**HISTORIC PRESERVATION REVIEW BOARD
STAFF REPORT AND RECOMMENDATION**

Landmark/District: **Anacostia Historic District** (x) Agenda
Address: **1340 Maple View Place SE**

Meeting Date: **June 23, 2016**
Case Number: **16-439** (x) Alteration

The applicant, property owner George Augustus Stallings, Jr., requests review of a permit application to construct a deck on the principal roof of this 1905 Queen-Anne-style detached, frame house. The project was underway when it received a stop-work order.

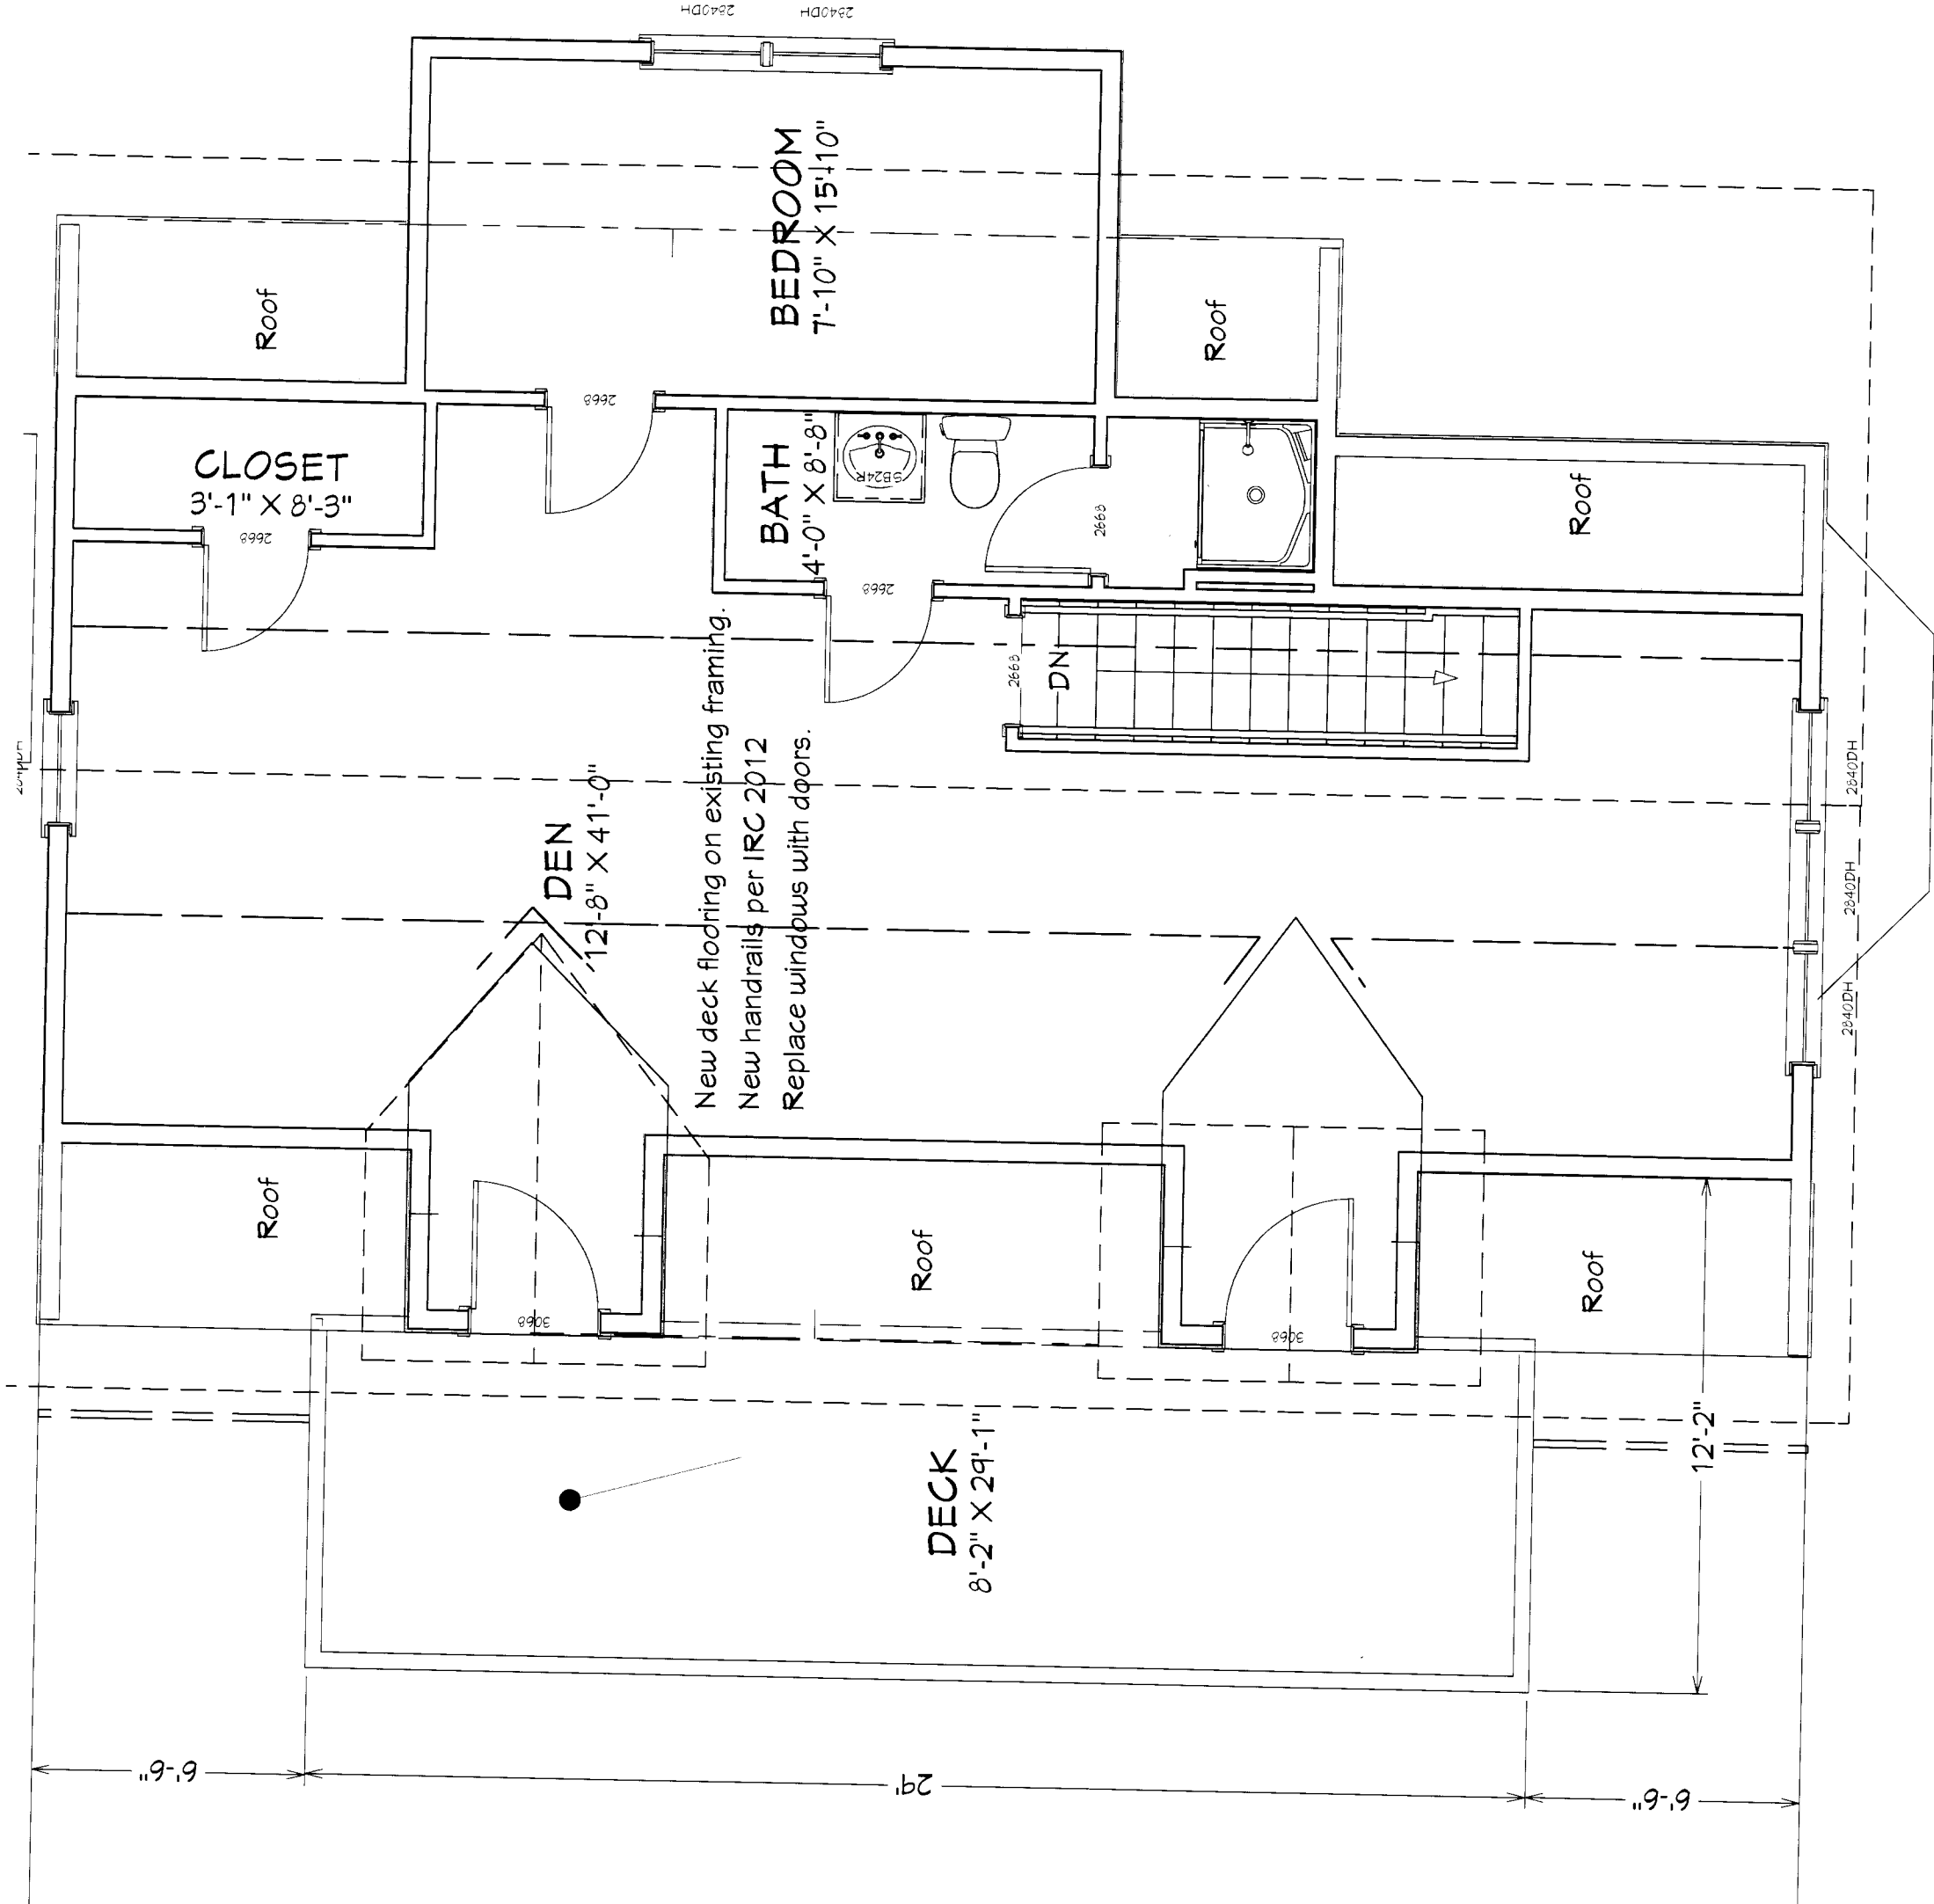
At the very least, the railing and decking were being replaced, and it appears that the roof had been modified by the addition of wing walls at the outside ends of the roof, to accept the railings and to direct water away from the dormers and deck.

It was clear that, although only a few years old, the deck construction had caused damage to the roof because of the failure of water to drain properly off the new surface (see photos below).

Aside from the physical alteration of the eave, the deck and its railing have the effect of obscuring view of the dormers, character-defining features of this house and this architectural style, original, albeit modified.

Left Side Elevation - Upper Level w/ Deck

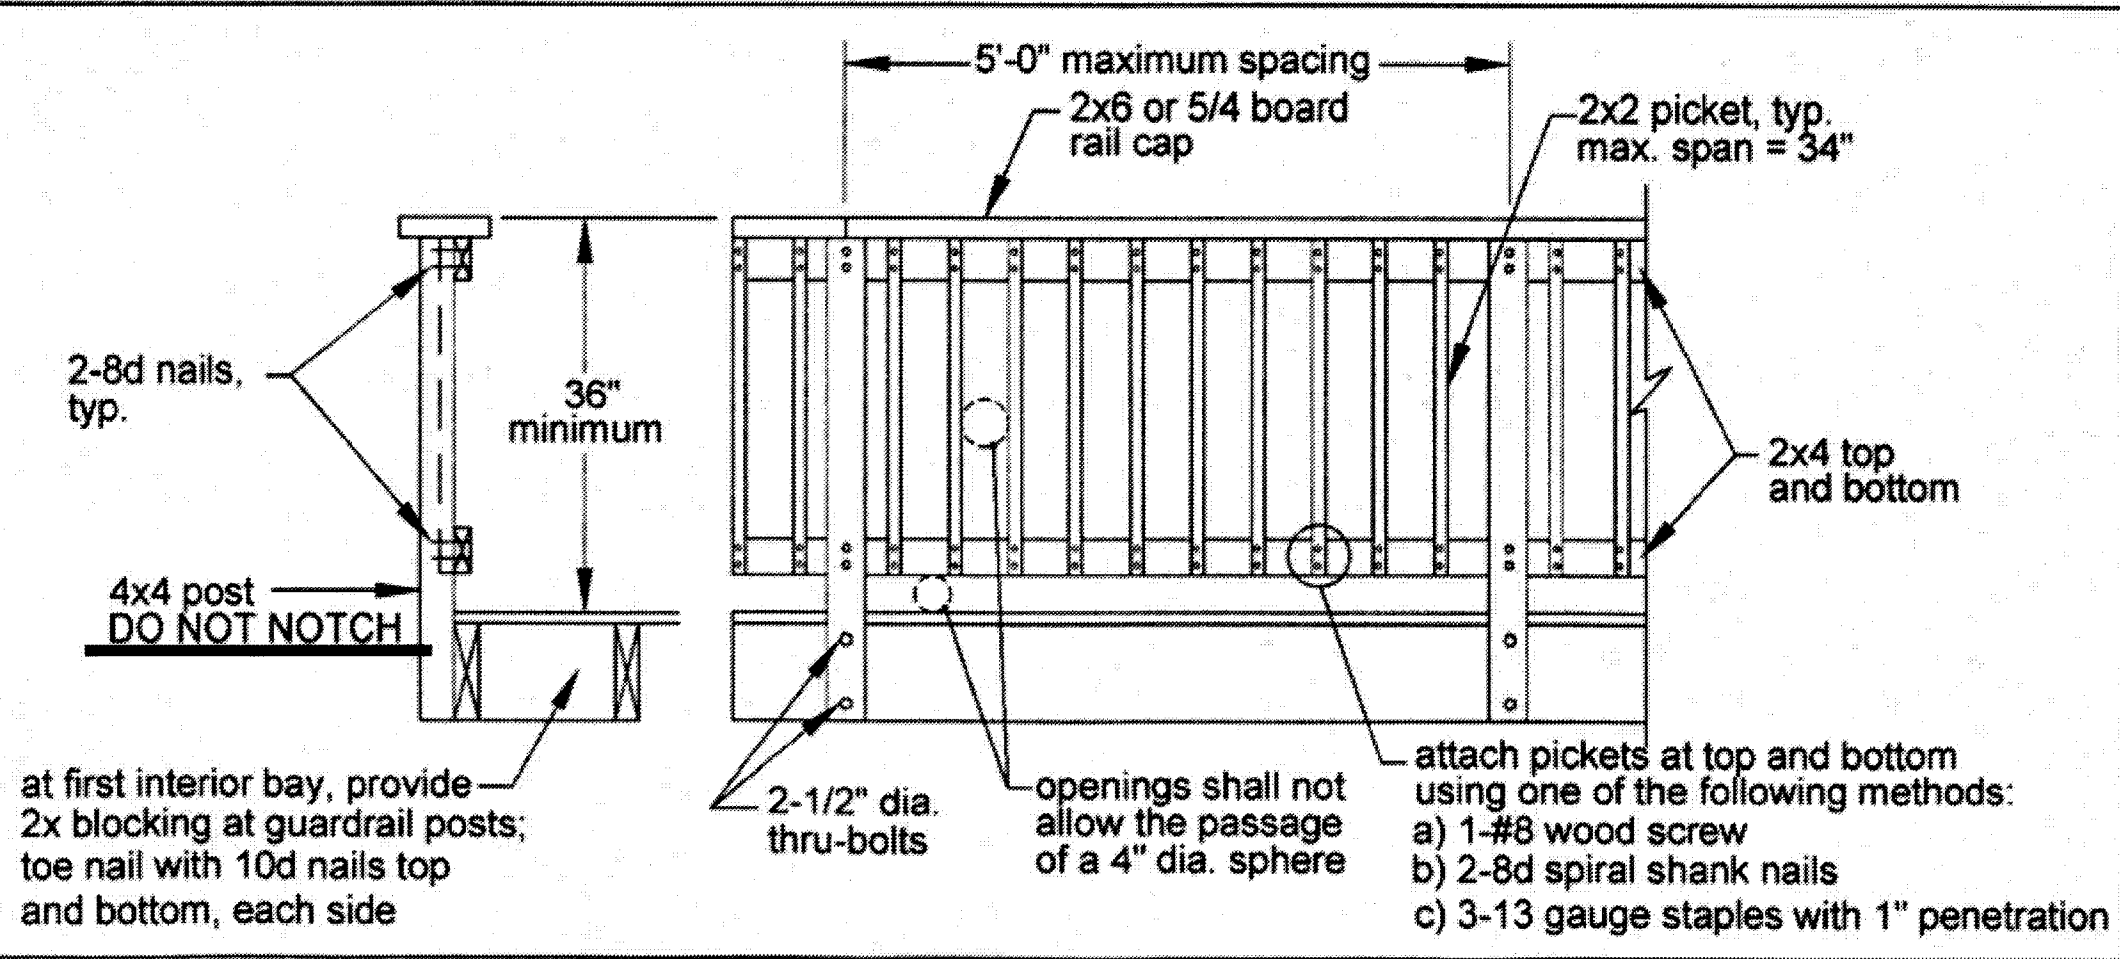
The permit application now proposes to swap the windows/doors in the dormers for Craftsman-style doors, which would stray farther from the original style and condition. It should be noted that the architectural drawings are inaccurate as to the height, roof pitch and details of the dormers, and do not represent the wing walls.

The proposed rail is very much a deck rail—widely-spaced, face-nailed, pressure-treated—suited to a rear-yard deck and not to a roof on a prominently visible side of a high-style house. Code-complaint deck rails are proportionally too tall to place prominently atop most historic houses; they are taller than historic porch balustrades, let alone roof balustrades.

HPO recommends that the Board recommend denial of a permit for the construction or reconstruction of the roof deck and alteration of the dormers as incompatible with the character of the property and the historic district and thus inconsistent with the purposes of the preservation law.
